# LAND USE APPLICATION FORM

**File Number(s):** GLUA-21-00001 and HR-21-00001 through HR-21-00005

Project Name: Canemah Cottages Number of Lots Proposed (If Applicable): \_\_\_\_\_

## TYPE III –HISTORIC REVIEW BOARD SUBMITTAL

**House #2** (This home is 150' from right of way and partially visible)

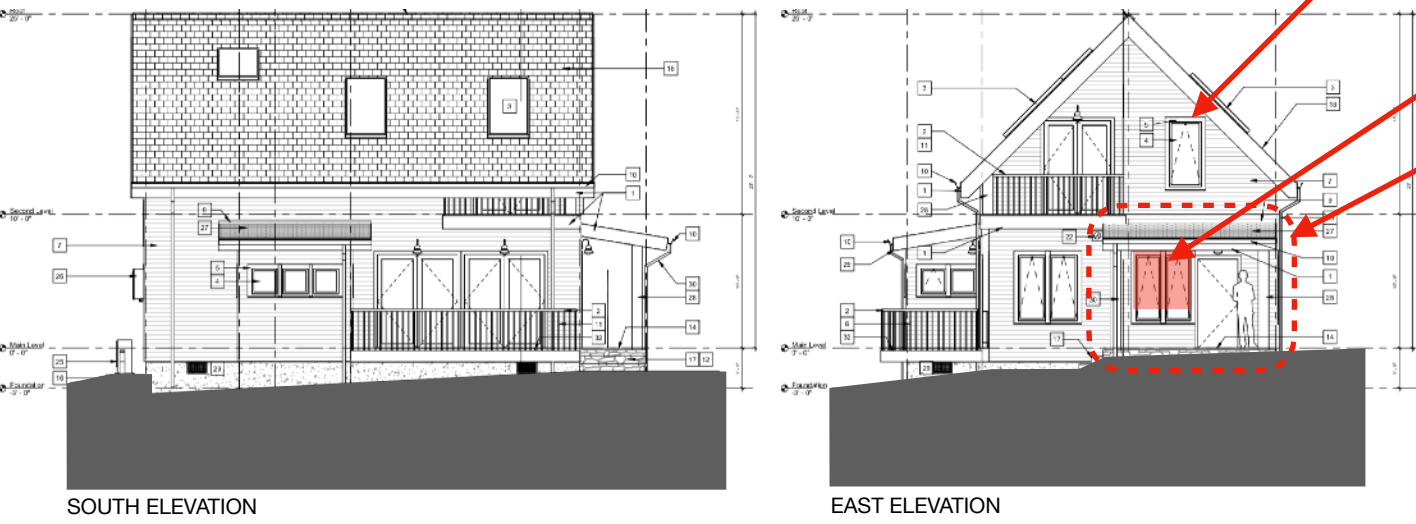
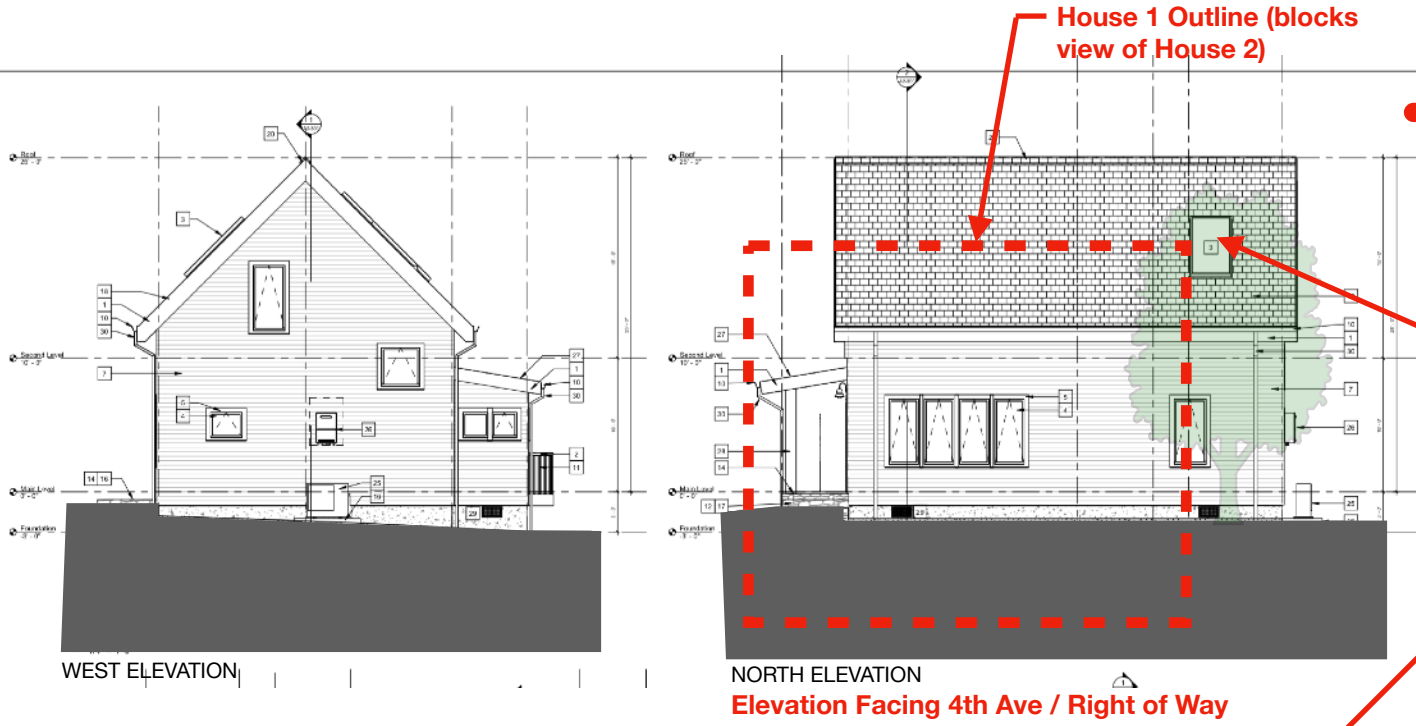
➔ Note: All windows are recessed 1.5" from face of trim. Neither Historic Guidelines, nor original COA specify a window depth

➔ Fascia width is the same on all homes, was not specified in original HRB application; there is no specific fascia width requirement in Canemah.

➔ View of Skylight, facing 4th Ave ROW is mitigated by landscape; is flush with roof and inconspicuous.

➔ Entry porch and door added to front of home. (Original HRB application did not show an entry or porch. Meets historic guidelines and is similar to all the cottages).

# House #3

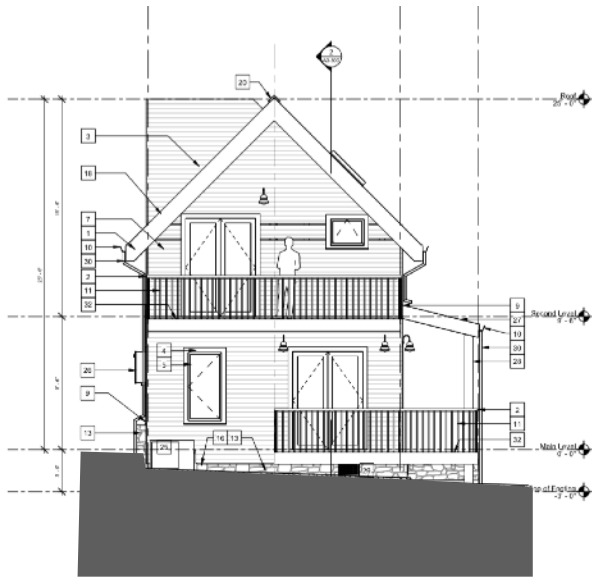
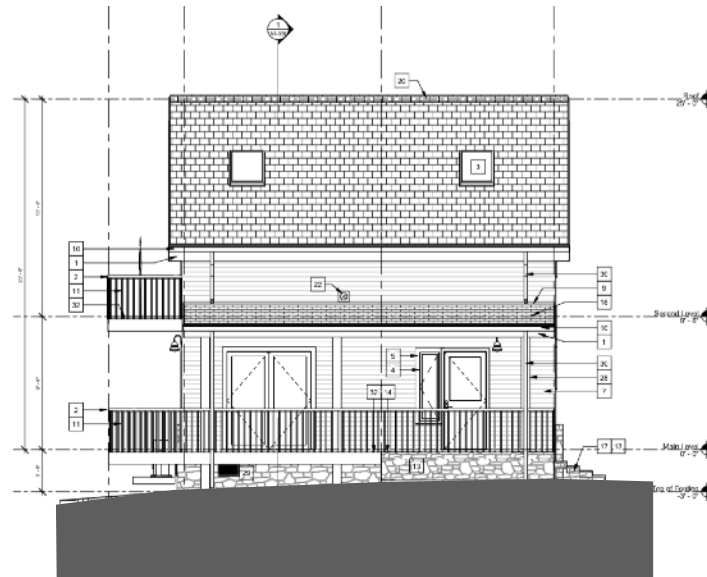
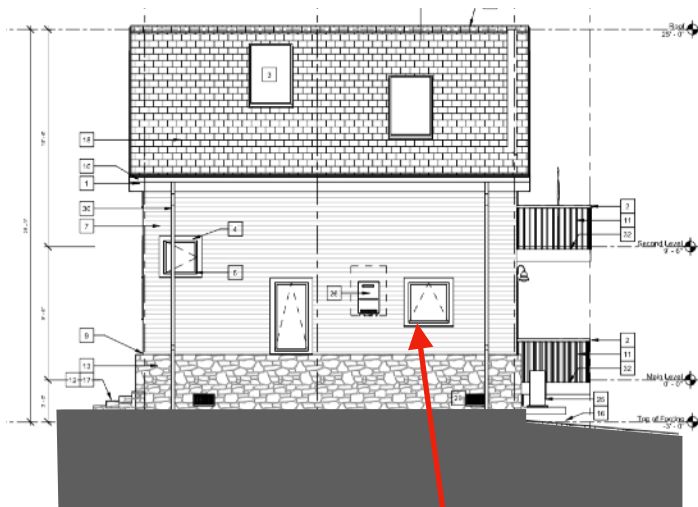
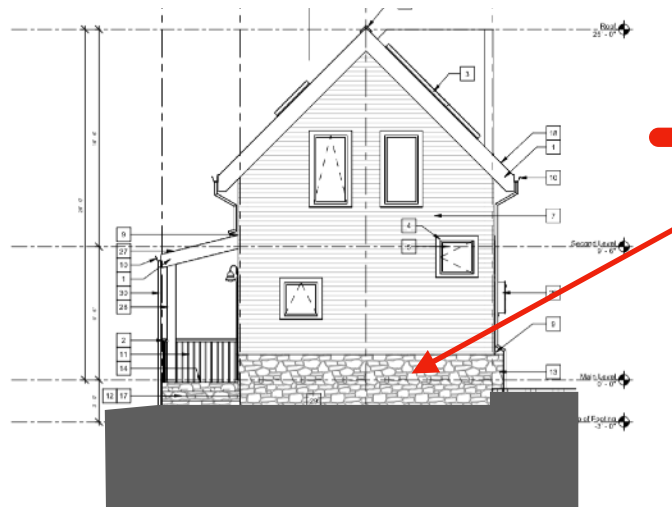
Massing and Height the same as Houses 4 and 5

Window changed to square

All Homes - Stone veneer replaced with typical concrete foundation - meets historic standards

# House #4

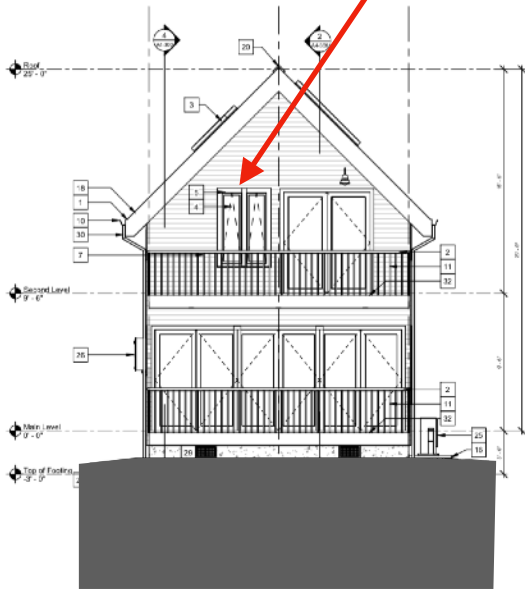
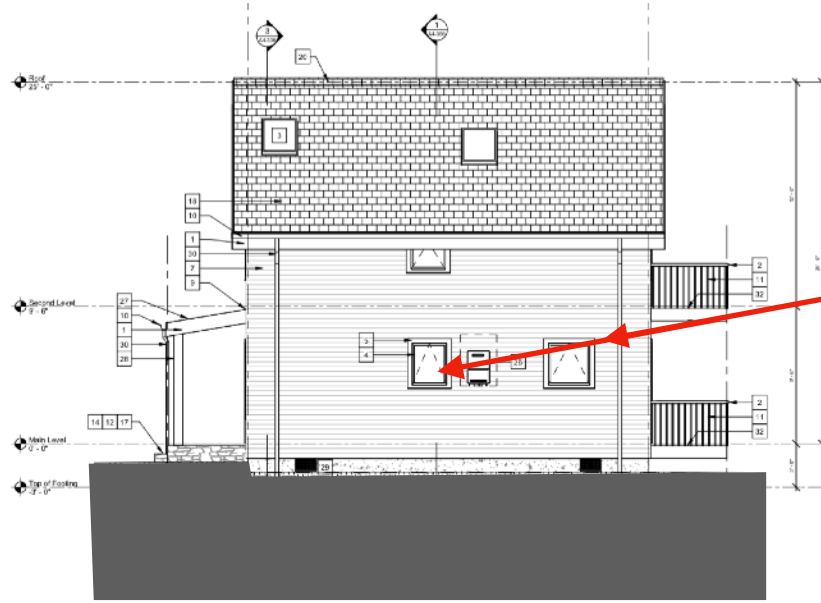
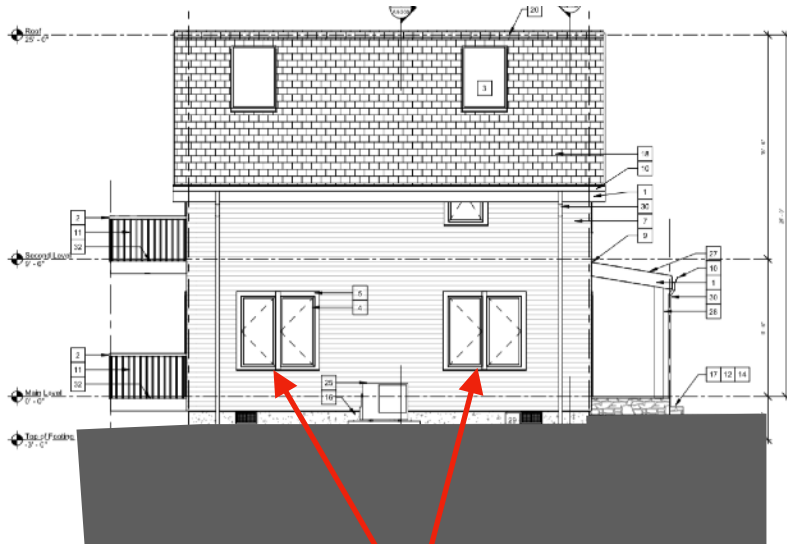
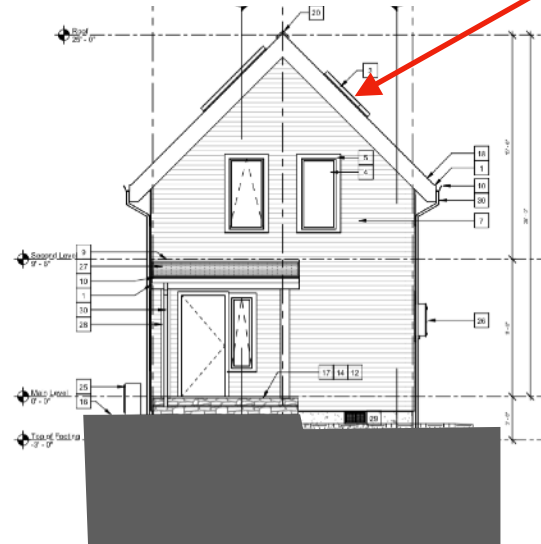
Window changed to improve natural light

Window size changed to square

Skylight is not facing right of way and is not visible from right of way; historic guidelines reference - *"skylights shall not be in roofs facing ROW"*

Windows added to improve natural light; more consistent with all homes

All Homes - roof overhangs reduced; more consistent with Canemah homes than original application.

# House #5

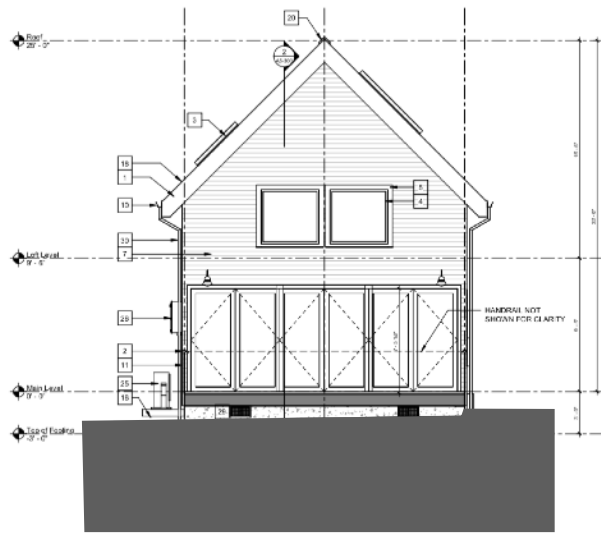
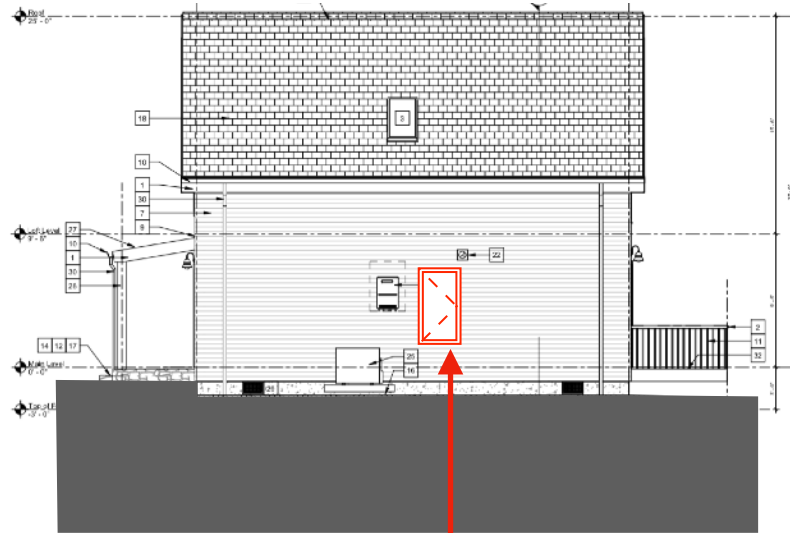
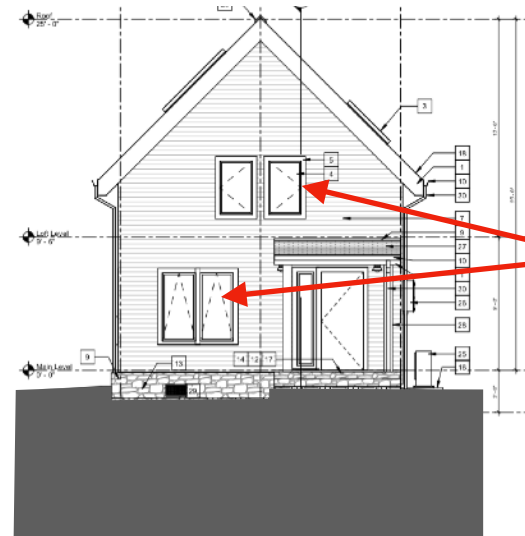
Porch projection added for consistency with other homes.

Window to be added to this elevation

**Original HRB Application - Site Plan**

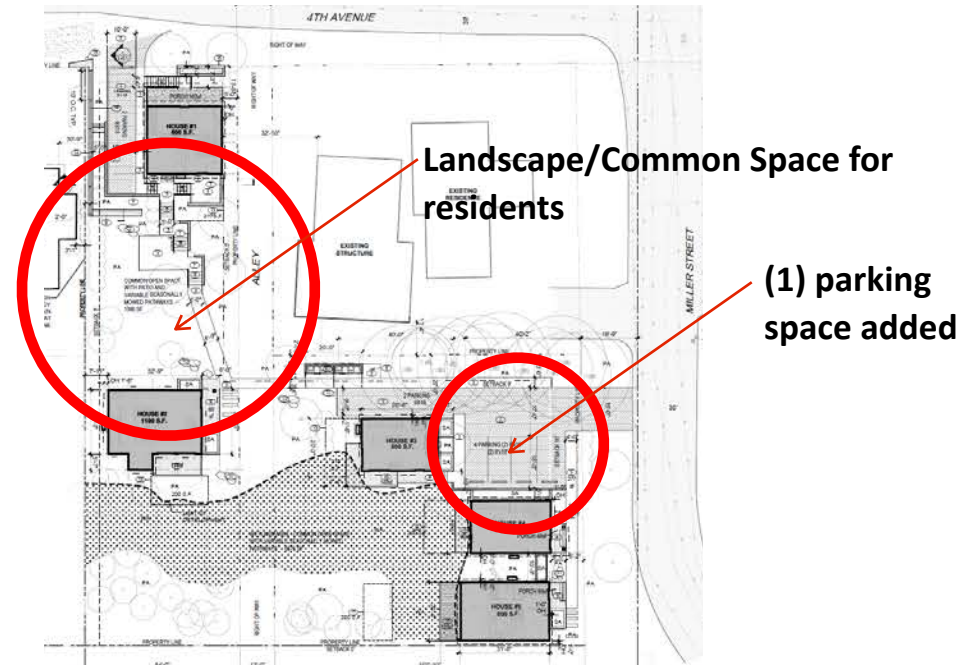
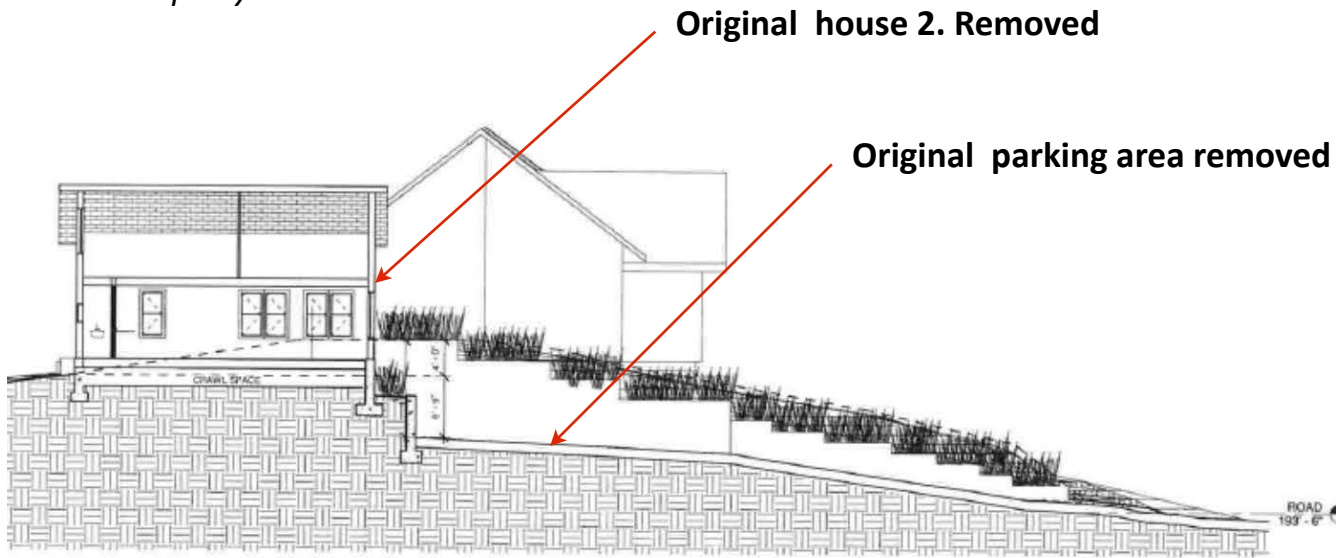
Changes from HRB Approval	Compatibility Proposed Mitigation
House 2 Removed	Per HRB COA's
Parking Area removed behind house 1. One space added by house 4.	Changed due to reduced parking and to minimize grading impact; Compatible w/Historic District.

### House #1 Property Line Wall

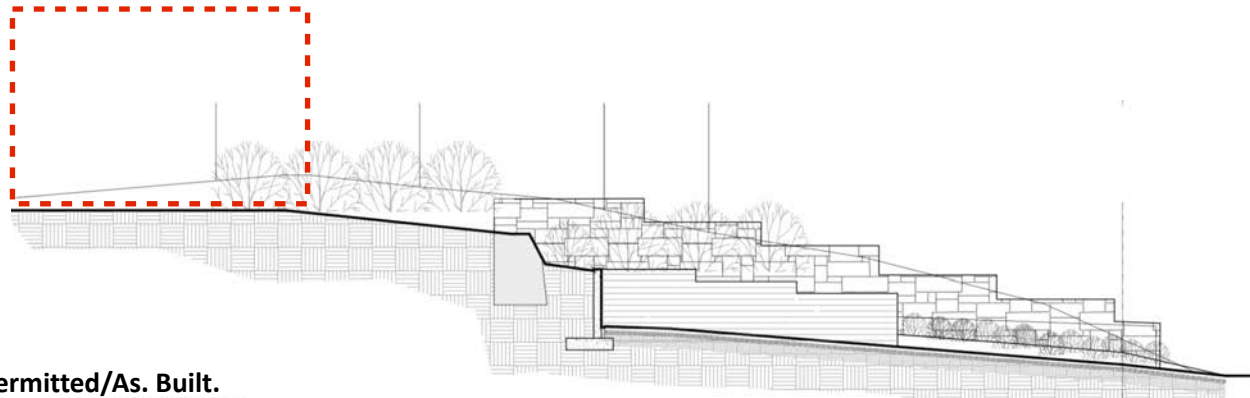
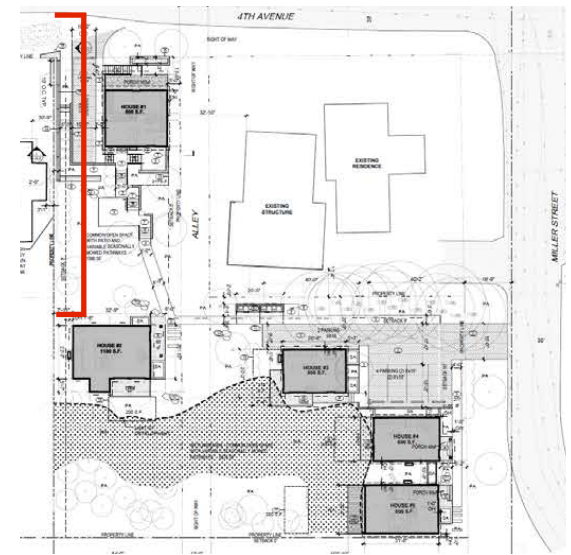
Changes from HRB Approval	Compatibility Proposed Mitigation
House 2 Removed	Per HRB COA's
Parking Area removed behind house 1. One space added by house 4.	Changed due to reduced parking and to minimize grading impact; Compatible w/Historic District.

Site Area south of House 1 and North of House 2

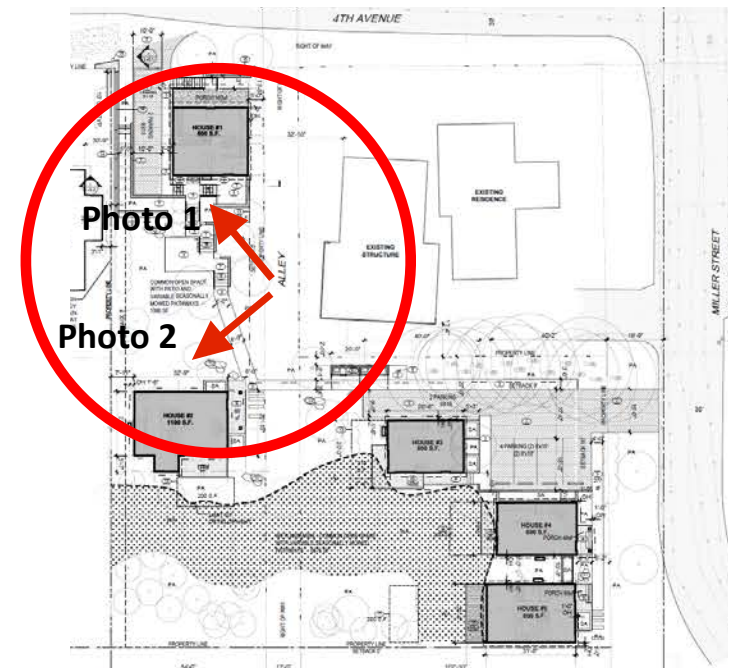
Changes from HRB Approval	Reason for Change / Compatibility Proposed Mitigation
Original House 2 removed	Per HRB COA's
Parking Area removed behind house 1. One space added by house 4.	Changed due to reduced parking and to minimize grading impact. At or near original topography. Compatible w/Historic District.

North (front) elevation

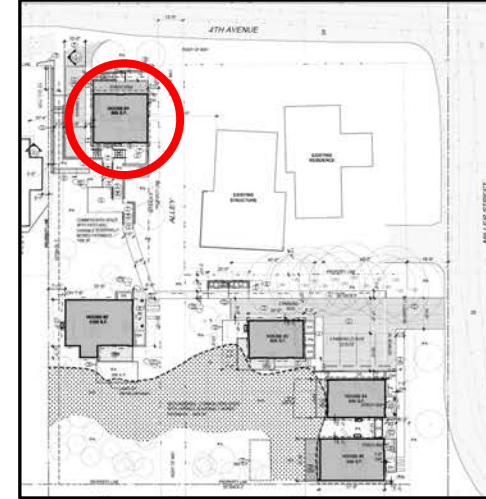
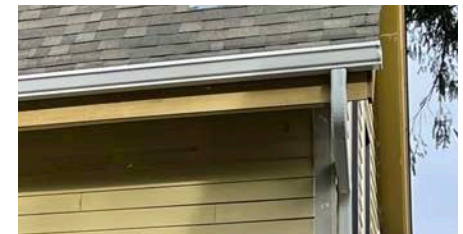
Changes from HRB Approval	Reason for Change / Compatibility Proposed Mitigation
Front porch stair orientation	Changed to reduce grading and visual impact in ROW; More Compatible w/ Historic Canemah character.
Siding is textured hardie plank, not wood	Actual wood cost prohibitive; Compatible w/Historic Guidelines.
Window member sizing, thickness, and shadowline does not match painted wood windows	Add 1" to Window Trim - only on elevations directly adjacent to ROW

**House #1**  
*South (rear) elevation*

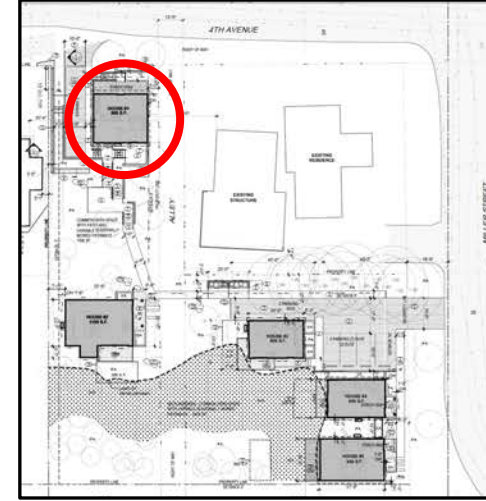
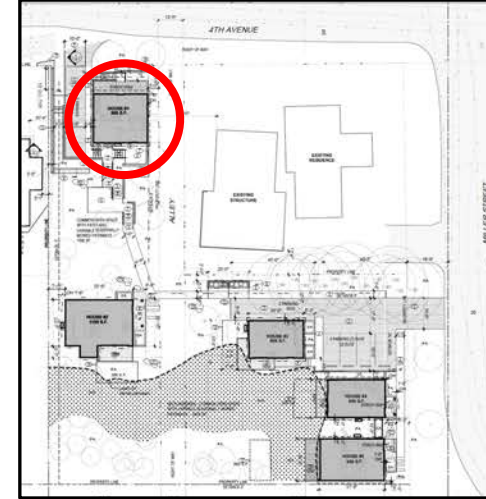
Changes from HRB Approval	Compatibility Proposed Mitigation
Window and door placement	Floor plan changed based on HRB COA's; Compatible w/Historic Guidelines.
Siding is textured hardie plank, not wood	Actual wood cost prohibitive; Compatible w/Historic Guidelines. Not visible from ROW
Fascia Profile - All Homes	Fascia's with rain gutter match HRB submittal; gable ends are 2" larger

East (side) elevation

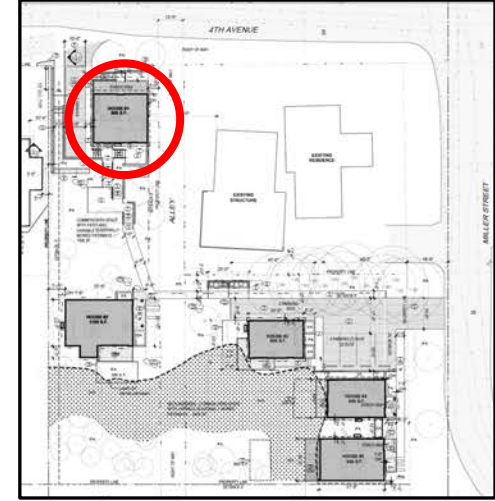
Changes from HRB Approval	Compatibility Proposed Mitigation
Addition of windows on upper right and lower left	Added window for bathroom and back porch; Compatible w/historic guidelines
Siding is textured hardie plank, not wood	Actual wood cost prohibitive; Compatible w/Historic Guidelines. Texture not visible from ROW
Window design	1:1 or 1:2 , Divided Lights on 1:2; compatible w/historic guidelines

East (front) elevation

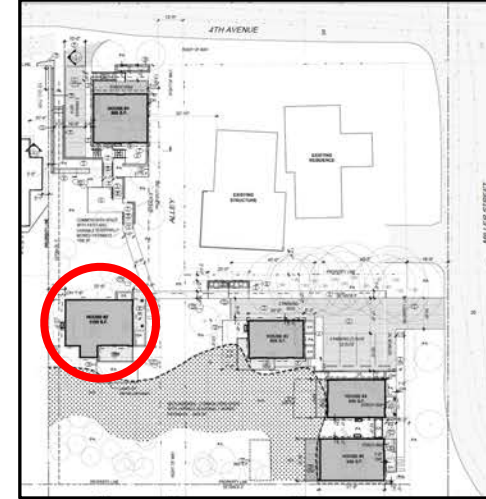
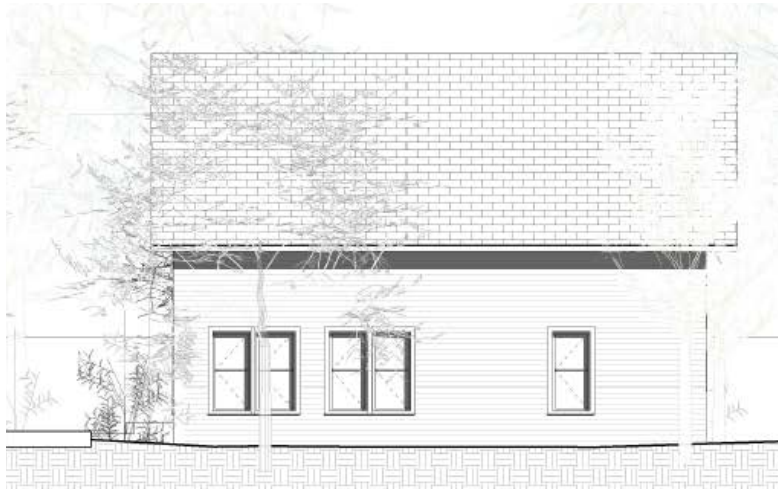
Changes from HRB approval	Compatibility Proposed Mitigation
Front door and porch added	Moved from south side for site access/function; Compatible w/ Historic Guidelines
Siding is textured hardie plank, not wood	Actual wood cost prohibitive; Compatible w/Historic Guidelines. Not visible from ROW
Removal of side porch roof and stair to minimize wetland disturbance	
Window member sizing, thickness, and shadowline does not match painted wood windows	Add 1" to Window Trim - only on elevations directly adjacent to ROW
